**RE: Responses to October 15, 2018 Adequacy Review Letter, Bad Boys Pit M-1996-081,
Teller County, Colorado**

Response to Elliot Russell Adequacy Review Letter Dated October 15, 2018

Permit No. M-1996-081

TITLE: BAD BOYS OF CRIPPLE CREEK MINING COMPANY, INC. PROPERTY EVALUATION
MAP ONE, EXHIBIT A - PERMIT APPLICATION - LOCATION MAP

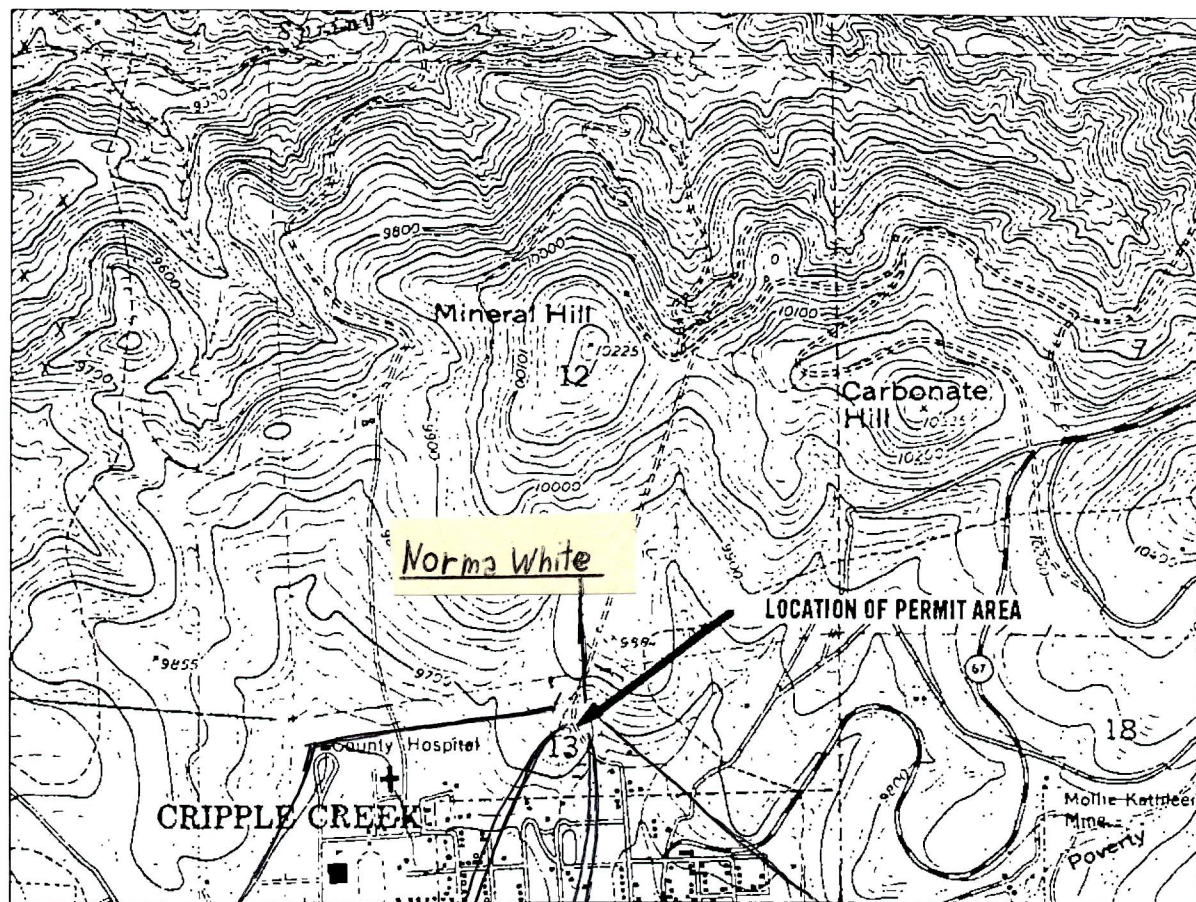
Comment 5: *Exhibit A contains two maps, Map One, Exhibit A- Permit Application – Location Map and an untitled parcel map. Neither map is signed in accordance with Rule 6.2.1(2)(b) nor specifies the coordinates of the main entrance to the mine site and the names of all immediately adjacent surface owners of record in accordance with Rules 6.3.1(2) and 6.3.1(3). Additionally, the*

untitled parcel map does not meet the minimum requirements of Rule 6.2.1(2) and incorrectly shows the proposed expanded permit boundary. Please update these maps and re-submit them for further review.

Response: The Rule requires a legal description using the range and township system, and the original engineer decided to add the size of his proposed permit area, even though the rule did not specify. I have updated his number to reflect the current size of the area. It appears that the original preparer provided a second map in which I do not access to, nor is required per Rule 6.3.1. Per 6.3.1(3), I have updated Map One by adding the names of the adjacent land owners and added the mine entrance coordinates; the same coordinate that you gave me to use in the application. Let's dispose of whatever you have for a second map in your Exhibit A, since it does not appear to be allowed per the regulation.

Soil Map—Teller-Park Area, Colorado, Parts of Park and Teller Counties

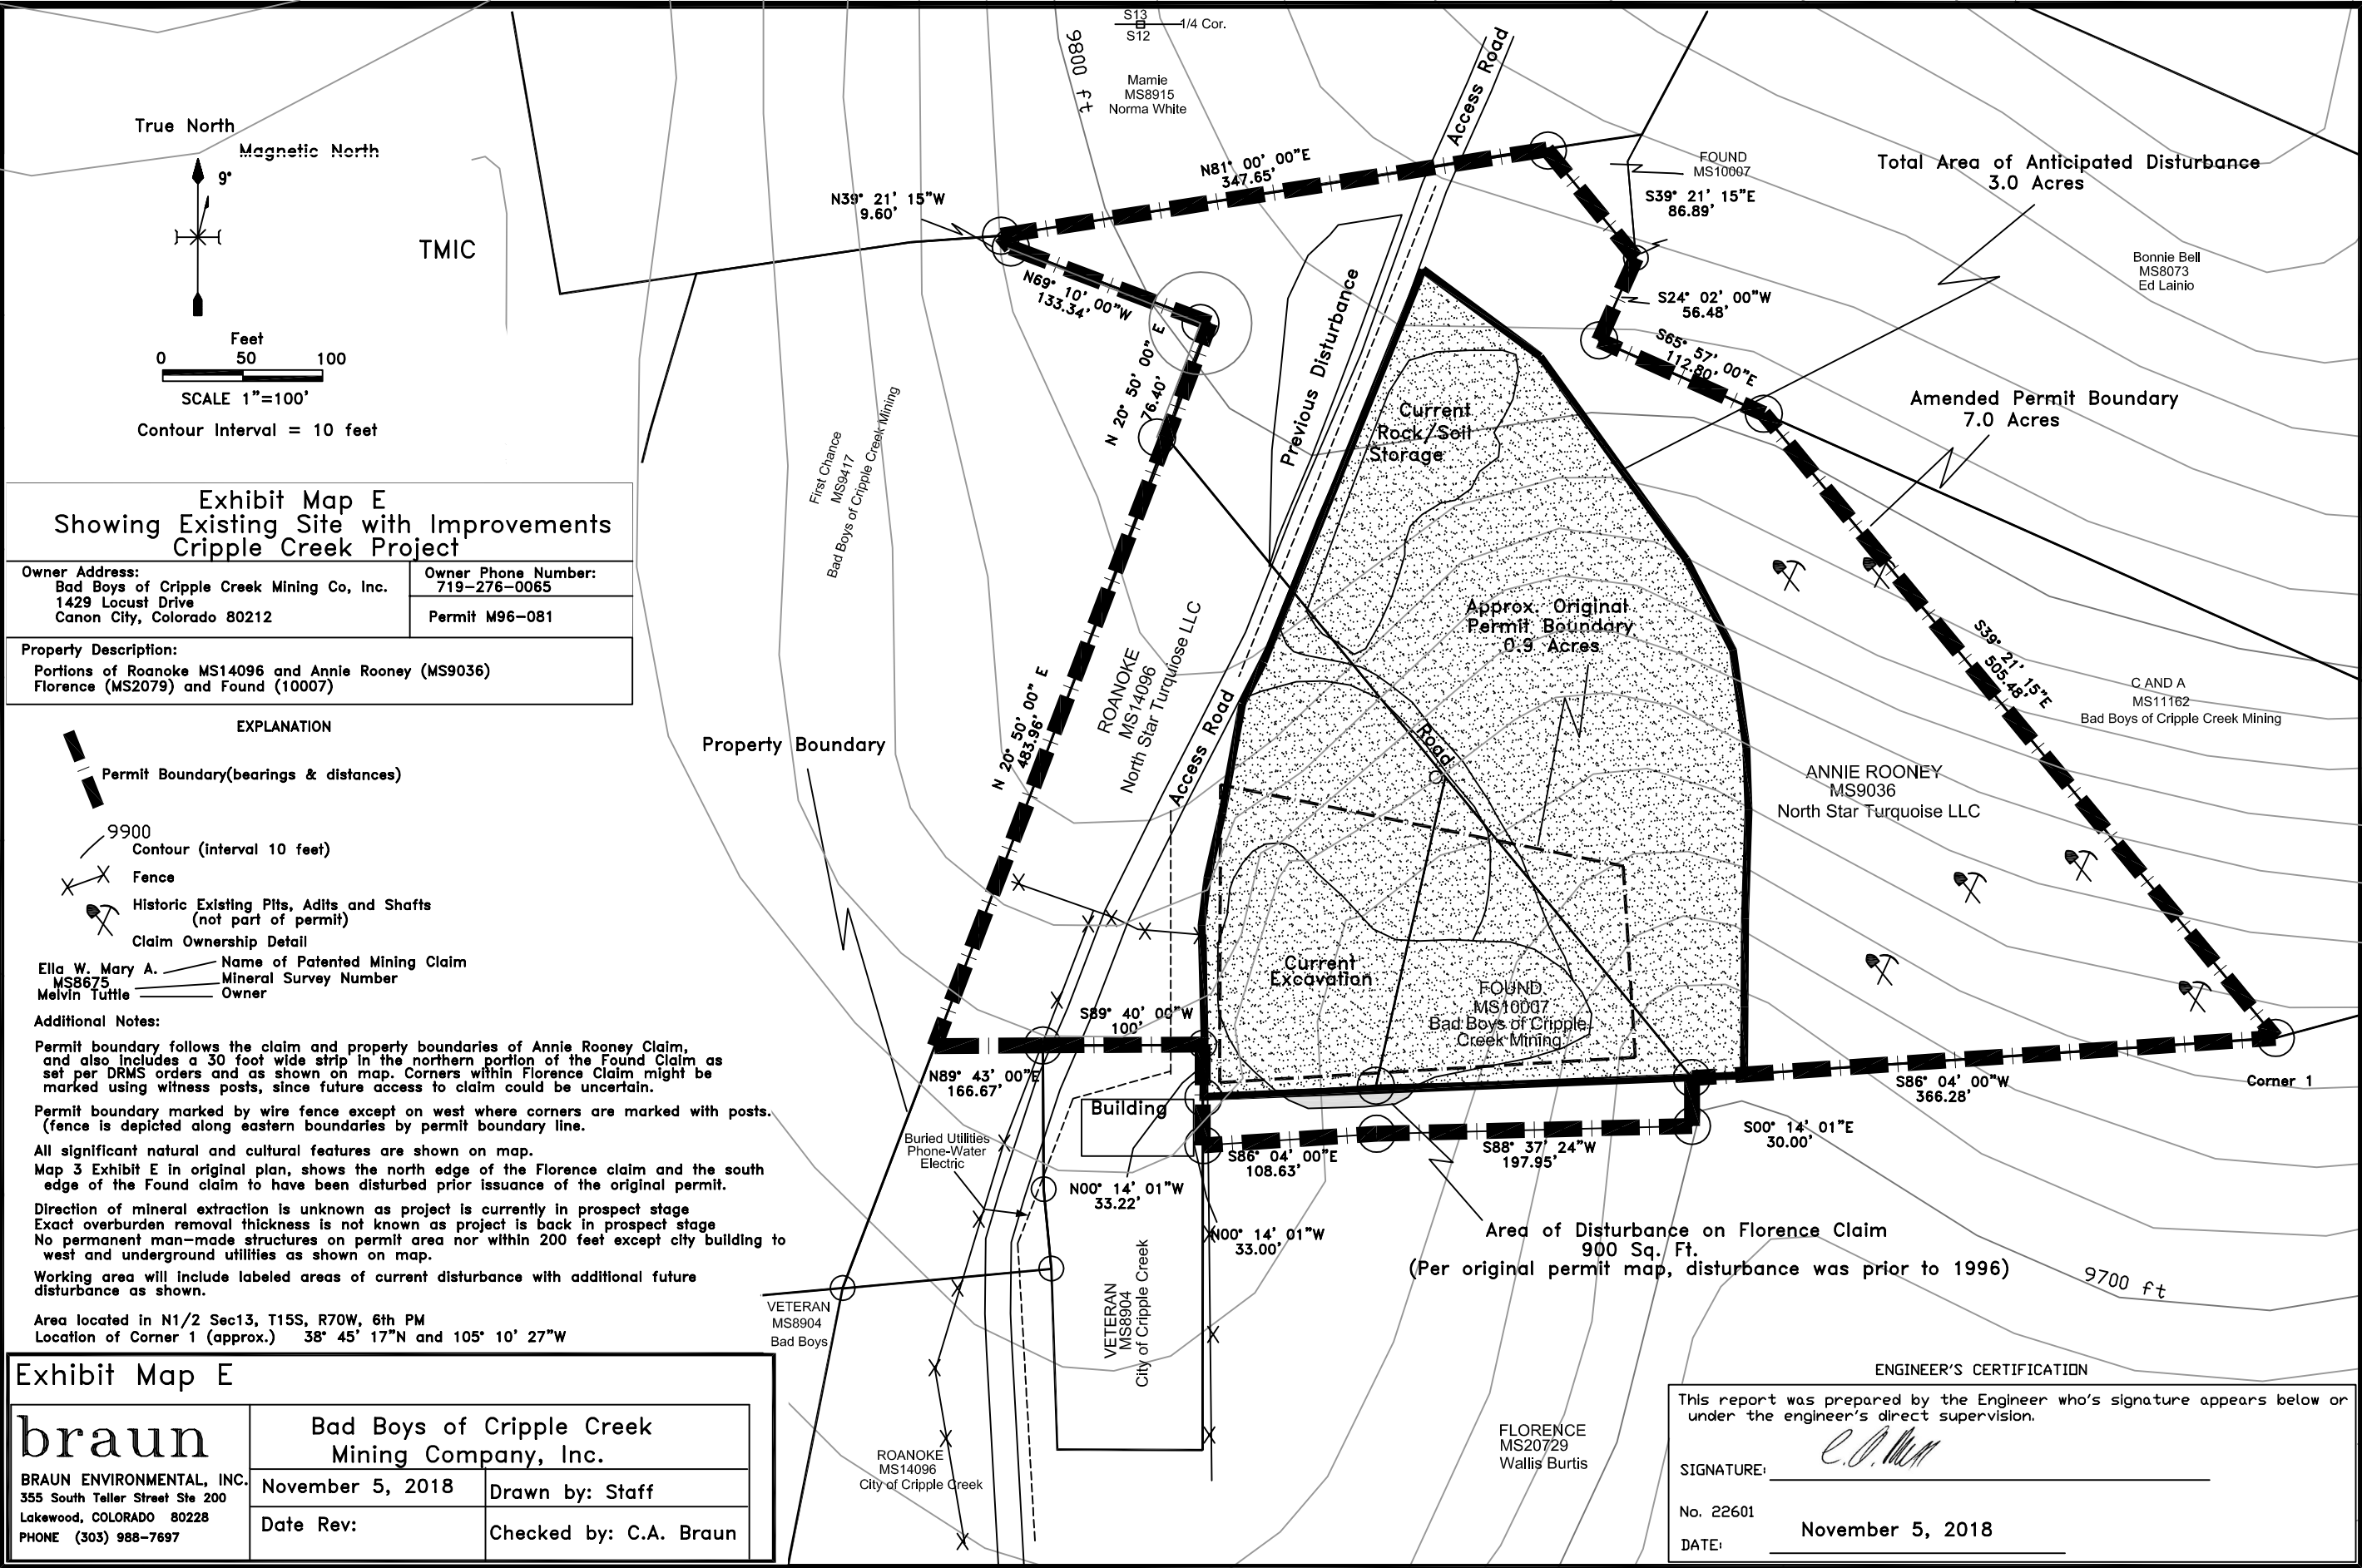
Comment 6: Within Exhibit B, the Applicant included a USDA Soil Conservation Information Sheets report to discuss the vegetation and soil characteristics at the site, however, this report and associated soil map are illegible. Please either obtain a more clear copy of this report or submit new information to comply with Rule 6.3.2(a). The Division recommends you contact the local NRCS office for assistance with this item. Please note, a Soil Report can be obtained from <https://websoilsurvey.sc.egov.usda.gov/> for free. Please identify the proposed permit boundary on the new soil report map.

Response: A new soils report has been produced and the permit boundary has been added. Thank you for the link to the website. It is interesting that the soils types listed in the area have little in common with the specific rock types that are the source of those soils.

Exhibit Map E-1 Reclamation Map

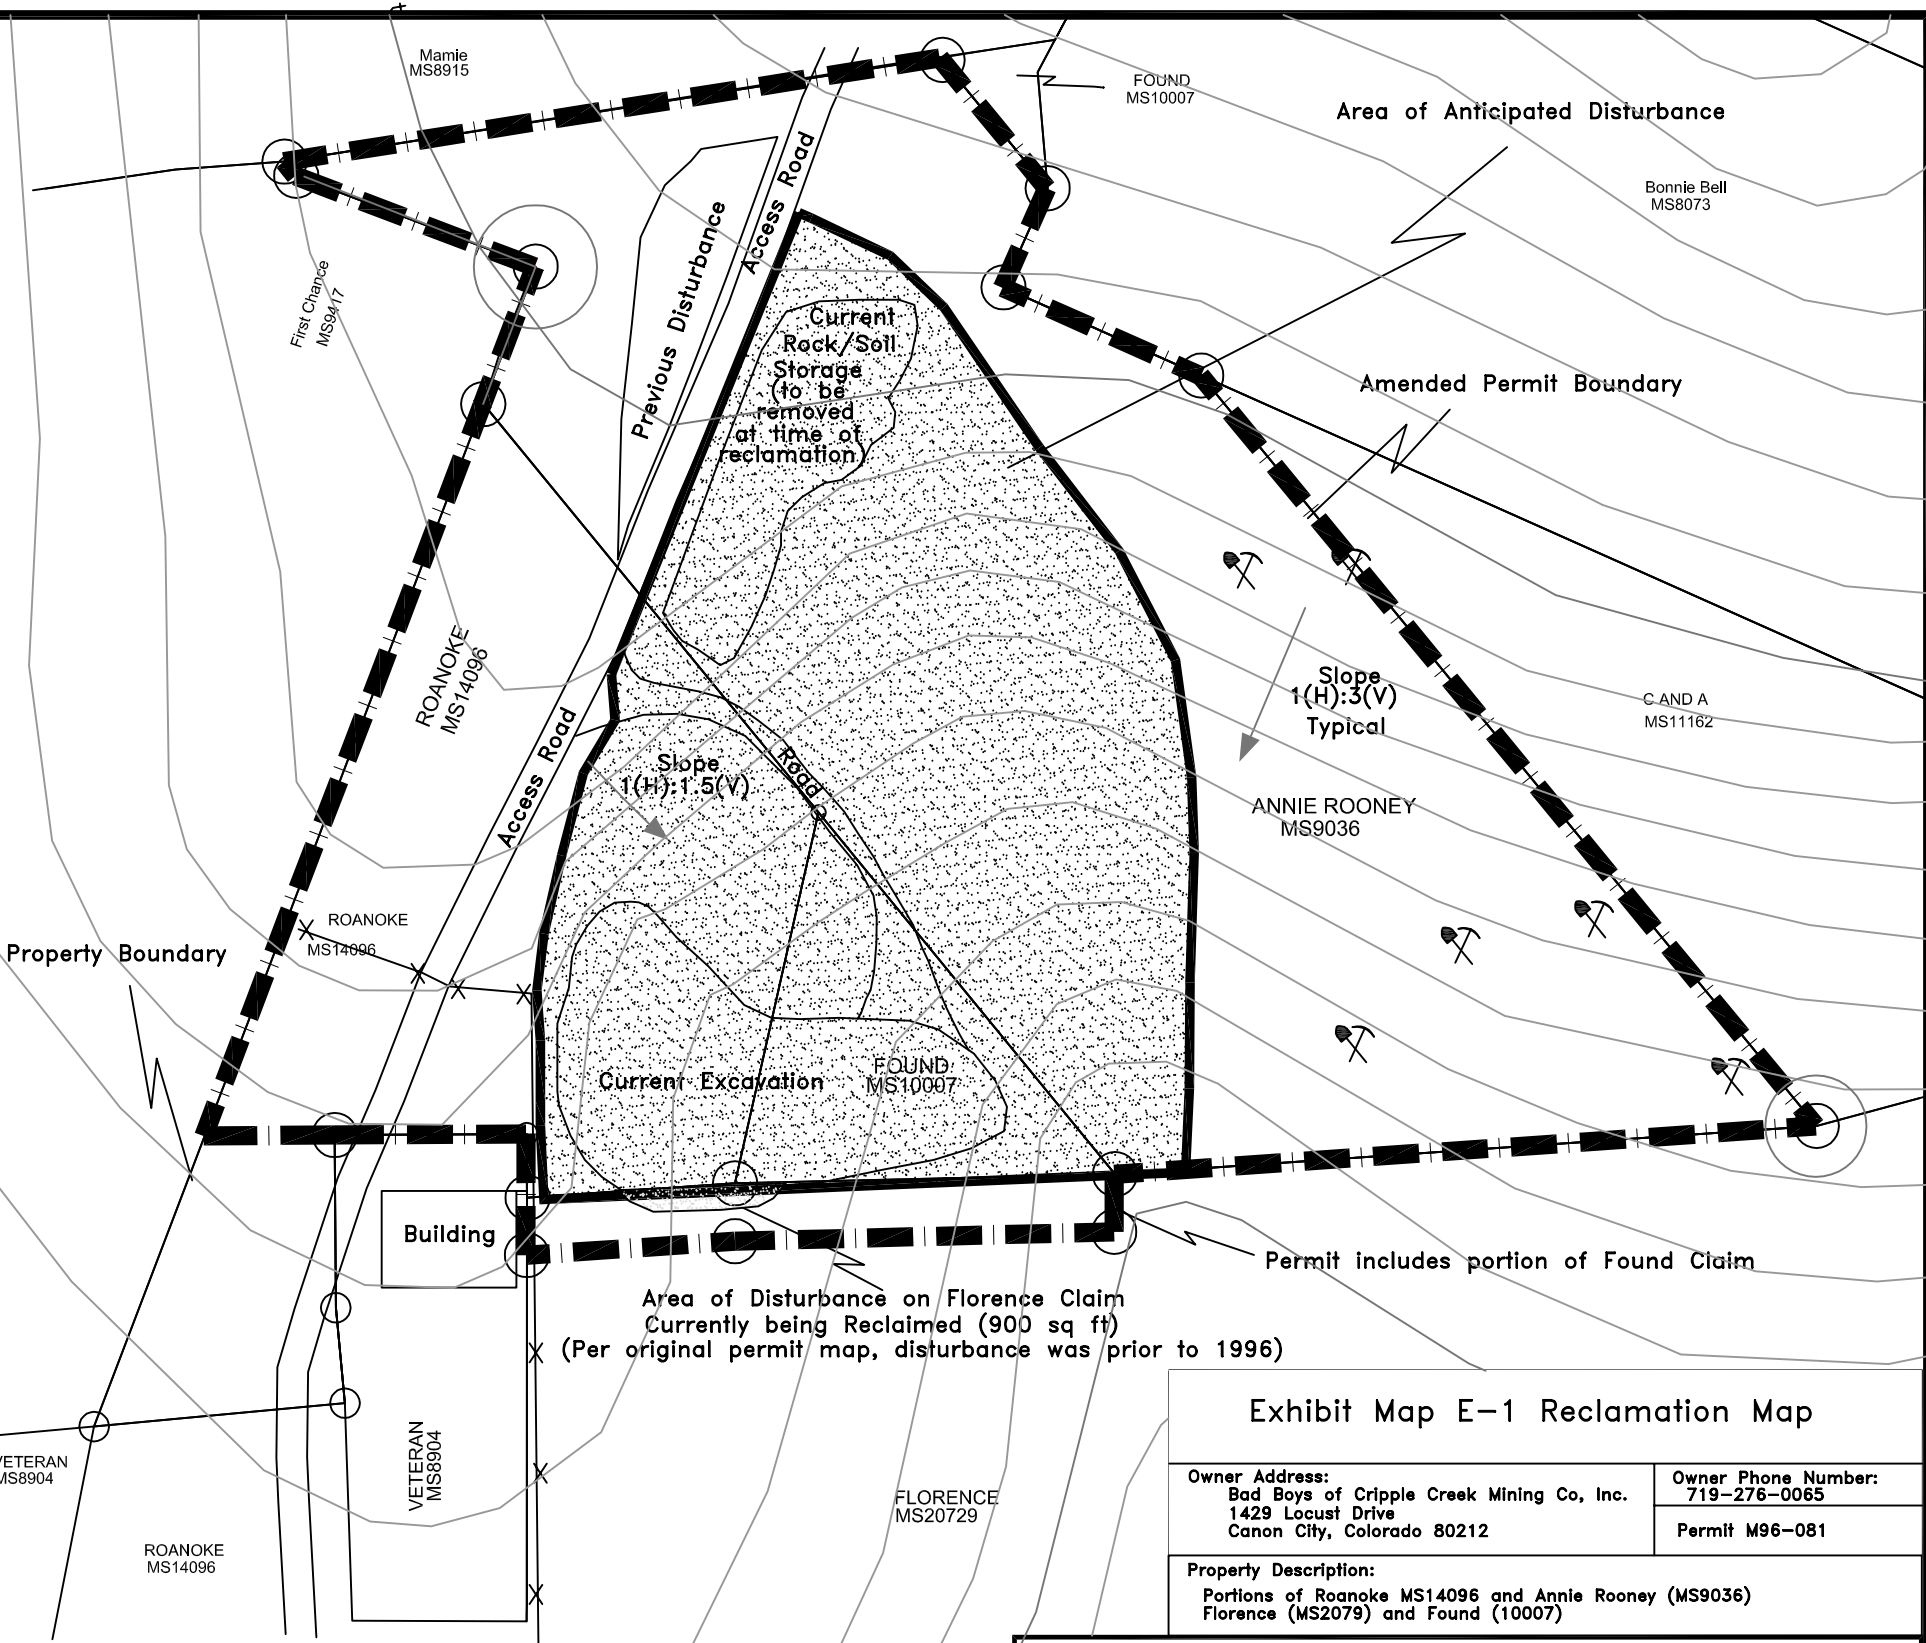
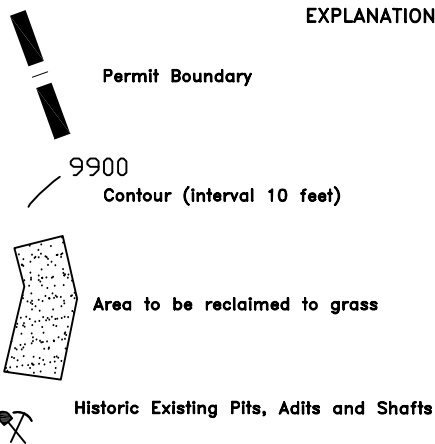
Comment 15: *The following adequacy items are associated with the Exhibit Map E-1:*

- a. *The title block includes an outdated address and phone number for the permittee. Please revise the Owner Address and Owner Phone Number identified in the title block.*

- b. *The title block includes an incomplete property description. Please revise the Property Description in the title block to include the Found MS10007 and Florence MS20729.*

- c. *There are various portions of the Reclamation Notes section on the map which are inconsistent with the proposed mining and reclamation plans (e.g. underground access areas, remaining cut banks, seeding rate, no fertilizer application). Please revise the Reclamation Notes section accordingly.*

- d. *Please remove the Current Excavation and Current Rock/Soil Storage polygons and labels as these feature (sic) will not remain after final reclamation.*

e. The map is not signed in accordance with Rule 6.2.1(2)(b).

f. In accordance with Rule 6.3.5(3)(a), please show the gradient of all reclaimed slopes (horizontal:vertical) sufficient to describe the post mine topography. The Applicant may also show the post mining topography with contour lines. As the proposed mining and reclamation plans detail, the site will be backfilled to similar pre-mine topography so the Applicant may want to simply use the contour lines provides on Exhibit Map E.

g. In accordance with Rule 6.3.5(3)(d), please state the average thickness of replaced overburden/waste rock.

h. In accordance with Rule 6.3.5(3)(e), please state the average thickness of replaced topsoil.

Response: There is no Rule 6.3.3(b), so the assumption is that the reviewer was referring to 6.3.3(1)(b). Soil will be stockpiled at the current location and in the same manner as shown on the Exhibit E maps (Map E and E-1). Additional wording has been added to Map E-1 to address the stabilization and seeding comment.

Response: Items have been updated on both Exhibit E maps

Response: Items have been updated

Response: I see no inconsistencies with the notes on the Exhibit E-1 map as related to the original mining and reclamation plan, other than a typographical error on the seeding rate. The map notes have been modified to include 33.4 pounds of pure live seed per acre. The phrase "underground access area" refers to the access area to the pit which is below the ground surface. I know of no more appropriate mining term to use for this description. As for the term "cut bank", if you recall, the west side of the permit area laps up against a steep little ridge to the northeast of the City building, that likely was originally a rock outcrop and at least exposed prior to the current permit. In the event that the valley cannot be filled to produce an appropriate surface slope, this possibility has to be considered. If your expertise can come up with another approach, let me know and we can make a design change. While the technician might overlook this possibility, the specialist will recognize it. Neither or the original design engineer in 1995 recommending fertilizer, so both the original and update version are consistent.

Response: I want to make our drawings as concise and understandable to the future user as possible, thus I am leaving the area labeled. It seems intuitive that the stockpile would be used during reclamation, but your advice is good and the words "to be removed at the time of reclamation" have been added to make the intent even more clear. I believe it to be important to make or drawings as useful as possible to the people that will need to figure them out down the road.

Response: There was not much reason to sign a drawing that was certain to be crayoned up by DRMS. This version is signed.

Response: Topography has been added to the Exhibit E-1 map along with two labels showing surface down-gradient direction at appropriate locations.

Response: Since this is a small mine, and since it is actually mostly in exploration stage, the future for the mining phase is difficult to predict. As for overburden removed, I would estimate it to be about one foot, since the mineral of interest was originally found at the grass roots, or even on the soil surface. You have added the term waste rock to the basic rule, so as for waste rock, since the main excavation is currently down to a maximum depth of about 70, if we average 1 foot and 70 feet, we get 35 feet for the average thickness. I recall that when we put together the original regulations quite a few years ago, this idea was focused more on a coal seam or other bedded deposit, than for this type of deposit. As a result, to the reclamation specialist, the answer to the rule in this case does not make all that much sense.

Response: Since the topsoil in the area ranges from zero inches to 8 inches, the average would be three inches. A weighted average would most likely be about 6 inches.
